SUBJECT: Withdraw of the November 16, 2015 Application for Modification, AND Application for Modification with Additional Information for Section 404 Individual Permit and Section 401 Individual Water Quality Certification for the US-74 Monroe Connector/Bypass in Union and Mecklenburg Counties. STIP R-3329 and STIP R-2559, Division 10, Debit WBS Element 34533.1.TA1 in the amount of \$570.

Reference: US Army Corps of Engineers (USACE) 404 Permit issued May 8, 2015; Action ID: SAW-2009-00876
NC Division of Water Resources (NCDWR) 401 Water Quality Certification Permit issued March 6, 2015; NCDWR Project No. 02-0672 V3

The North Carolina Department of Transportation (NCDOT) is in the process of constructing the Monroe Connector/Bypass, as authorized by the USACE and NCDWR as referenced above. NCDOT is requesting a permit modification for ten Permit Sites: 3, 5, 29, 30, 37, 46, 47, 48, 54, and 57, which are detailed below. Two other sites, 6 and 60, have revisions in jurisdictional areas that do not require a permit modification (see below).

Permit Site 57 (Revised Permit Drawings 229 and 230 of 267):

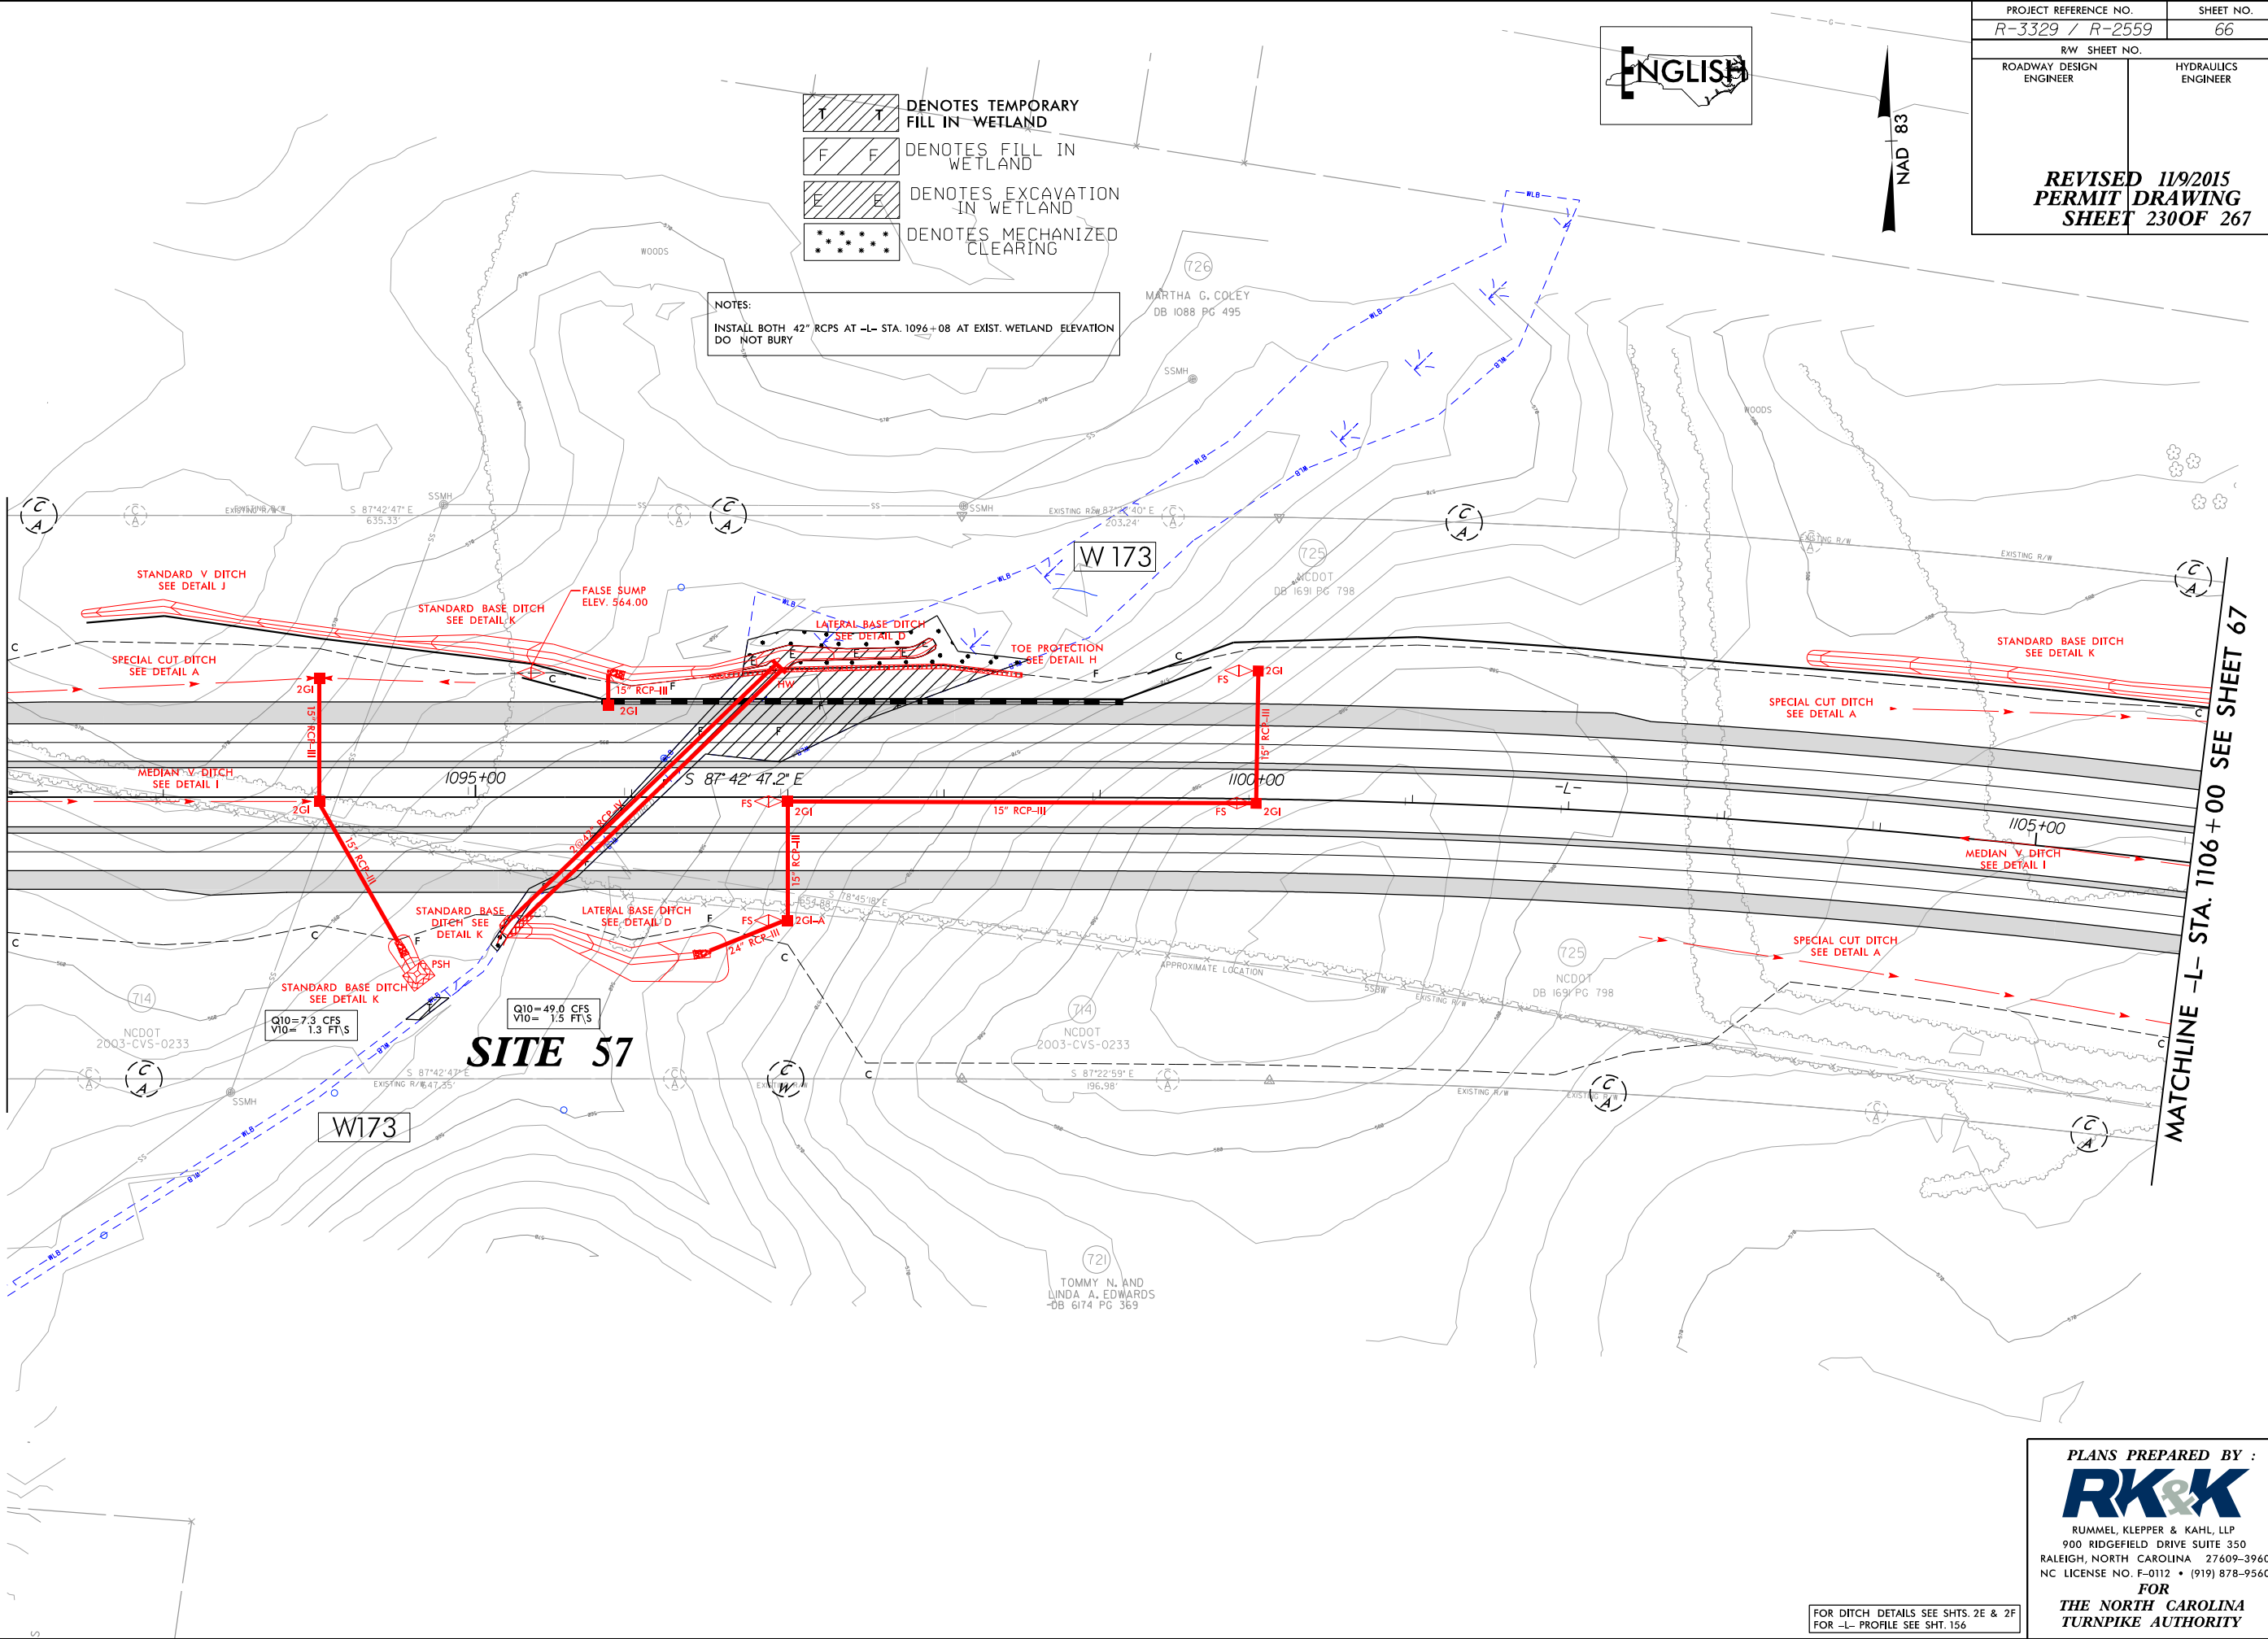
As you are aware from our correspondence on August 21, 2015, prior to the start of construction, environmental staff re-flagged jurisdictional areas for crews to install orange construction "avoidance" fencing. At the time, Site 57 was an active pasture. At some point between flagging and fencing installation, the flagging was removed. This precipitated several other events eventually resulting in the fill of a section of the Site 57 wetland, not previously authorized for fill. This resulted in approximately **500 ft² (<0.01 acre) of permanent wetland impacts.** Upon discovery and reporting of the error, the contractor was prepared to remove the fill and return the site to pre-construction conditions. However, after further discussion with Division 10 and Natural Environment Section, this impact allows for an expedited construction of the adjacent permanent pipe crossing. With this consideration, it was agreed to leave the temporary fill in place, expedite construction of the pipes, and remove the fill and return the area to its

natural state. The permanent crossing is expected to be completed in the next three weeks and the unauthorized crossing will then be removed.
